MS24184L
AMENDMENT 2
14 February 2001
SUPERSEDING
AMENDMENT 1
2 June 1998

DETAIL SPECIFICATION SHEET

RELAYS, ELECTROMAGNETIC, 300 AMPERES, 1PST,
(N.O.), TYPE I, WITH AUXILIARY CONTACTS,
HERMETICALLY SEALED

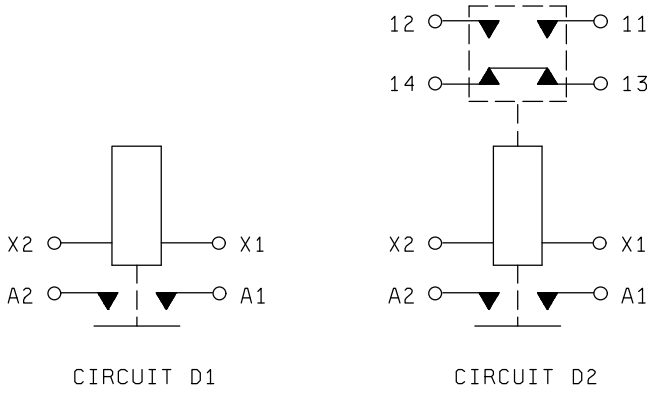
FIGURE 1, dimensions and configurations, delete CIRCUIT D1 and CIRCUIT D2 and substitute:
